February 20, 2019

Re: Jordan Cove Energy Project L.P. and Pacific Connector Gas Pipeline, L.P. Section 401 Water Quality Certification - Response to ODEQ Supplemental Information Request received December 20, 2018.

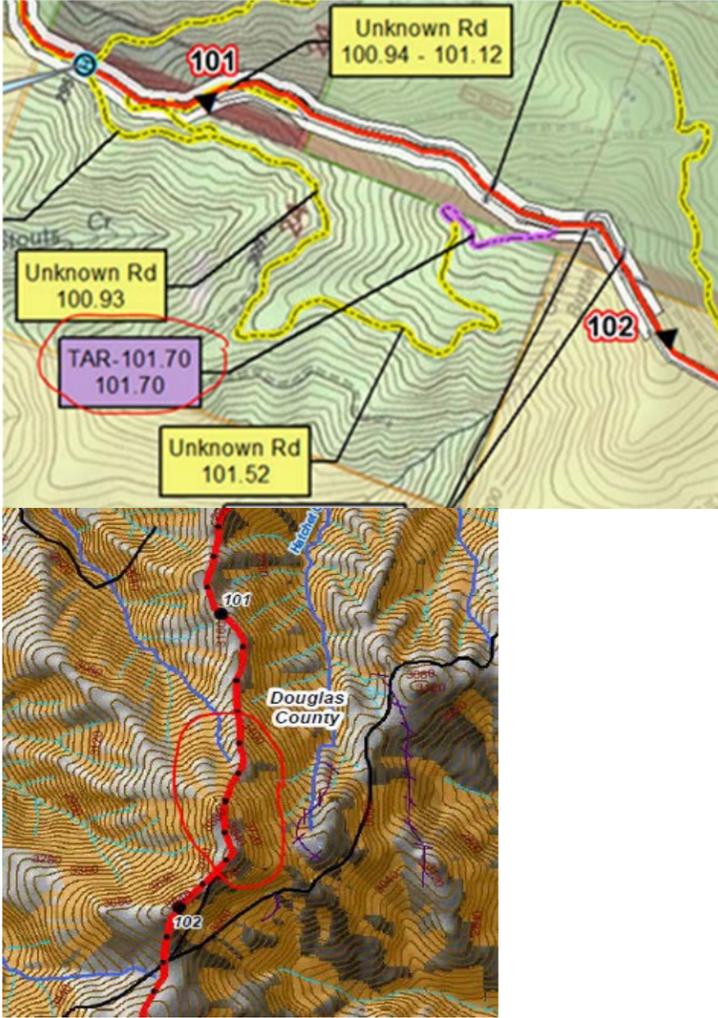
Comment No.	September 7, 2018 Information Request	October 8, 2018 Jordan Cove Response	December 20, 2018 DEQ's Review and Response to Jordan Cove's Response	February 20, 2019 Jordan Cove Response to December 20, 2018 ODEQ comments
	<p>Reserves is that larger setbacks "would render the TEWA useless for the stream crossing." PCGP should justify its proposal for non-standard riparian buffer protections by providing the following information:</p> <ul style="list-style-type: none"> • A description of the specific constraints at each site preventing the use of a TEWA in an area. • The specific rationale why the TEWA must be closer to the stream crossing. <p>Without this specific information, DEQ cannot determine that Pacific Connector Gas Pipeline attempted to first avoid and minimize riparian impacts to the maximum extent practicable before seeking to mitigate these impacts.</p>			
20	<p>This compliance assessment must also identify other locations where PCGP will not comply with Designated Management Agencies' riparian protection areas when siting the following:</p> <ul style="list-style-type: none"> • Temporary and Permanent Access Roads, • Staging areas, • Material storage areas, and • Other components (e.g., compressor stations, 	<p>PCGP will provide a response to DEQ in Q4 of 2018.</p>	<p>DEQ anticipates PCGP's response in Q4 2018.</p>	<p>Refer to response to Comment 21b.</p>

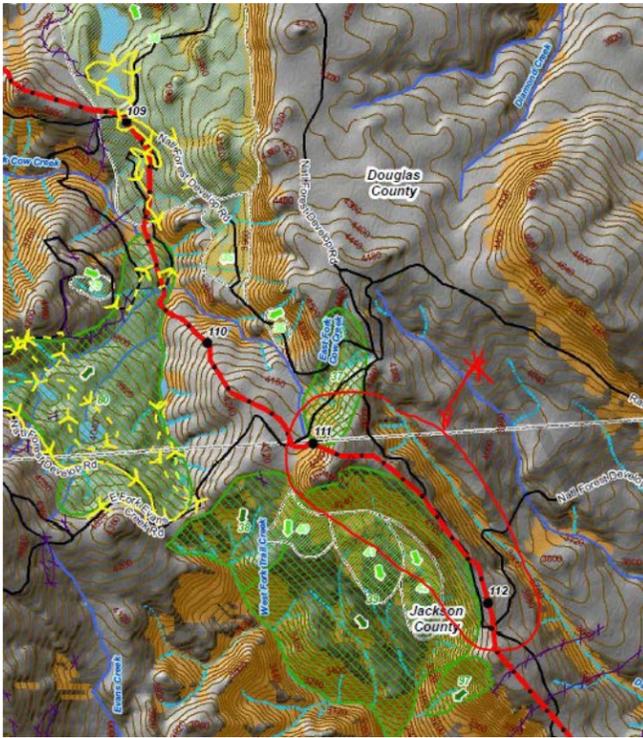
Comment No.	September 7, 2018 Information Request	October 8, 2018 Jordan Cove Response	December 20, 2018 DEQ's Review and Response to Jordan Cove's Response	February 20, 2019 Jordan Cove Response to December 20, 2018 ODEQ comments
			<p>support – that the soils and vegetation in between the slope breaker's discharge point and the stream will treat this stormwater discharge. Additionally, when the permanent right-of-way is in operation, PCGP does not provide DEQ with the water quality design storm that the proposed slope breaker collection system and/or natural area will treat. Moreover, PCGP does not demonstrate that the natural area (i.e., buffer area) between stream and the slope breaker's discharge point is capable of adequately treating the discharge from the water bar.</p> <p>In the absence of this detailed information, DEQ can only assume that PCGP does not sufficiently treat the runoff from the permanent right-of-way at stream crossings once discharged from the slope breaker to the stream. In Comment 34, DEQ requested that PCGP evaluate the water quality impacts from this discharge by using a model such as <u>X-DRAIN</u>. PCGP has not provided this evaluation in its response nor indicated it will provide this information to DEQ in the near future.</p> <p><u>Comment 35 of AIR-1 (Post-construction Stormwater Discharge from ROW to Steep/Unstable/Erosive Slopes)</u></p> <p>In PCGP's response to DEQ's Comment 35, PCGP refers DEQ to the Erosion Control and Revegetation Plan. As noted in DEQ's Comment 35, PCGP only provides generic diagrams for certain erosion control practices. This information does not provide site-specific information for how PCGP will avoid discharging post-construction stormwater to unstable slopes such as headwalls, Areas of Potential Rapidly Moving Landslide Hazards, and mapped landslides along the entire pipeline alignment. In DEQ's review of PCGP's response to Comment 15 noted above, DEQ provides the regulatory and technical basis for avoiding post-construction discharges to steep, unstable slopes from the pipeline's right-of-way. For example, in its Erosion Control and Revegetation Plan, PCGP indicates that it will use permanent slope breakers (i.e., water bars) across the right-of-way on slopes to:</p> <p style="padding-left: 40px;"><i>...minimize erosion by reducing runoff velocities by shortening slope lengths, preventing concentrated flow, and by diverting water off the right-of-way. Slope breakers are also intended to prevent sediment deposition into sensitive resources.</i></p> <p>DEQ addresses the deficiencies of this plan excerpt from the ECRP in DEQ's review of PCGP's response to Comment 34 above. This represents all the information PCGP provided to DEQ in its submittal. The information that PCGP has provided in its submittal, to date, lacks site-specific information regarding the discharge points for these slope breakers. Also, without additional information, DEQ is unable to determine if these discharge points will:</p> <ul style="list-style-type: none"> • Add additional water to unstable slopes (e.g., headwalls, high Rapidly Moving Landslide Hazard Potential Areas, mapped landslides) • Produce positive soil pore pressures that may cause landslides that impact water quality. <p>As noted PCGP's submittal, slope breakers are specialized drainage ditches to prevent stormwater from eroding the right-of-way and creating rills and gullies in this right-of-way. PCGP's response did not provide DEQ with a post-construction stormwater management plan for the management of stormwater for the approximately 117 miles of the proposed pipeline right-of-way traversing steep slopes (i.e., slopes greater than 30%).</p>
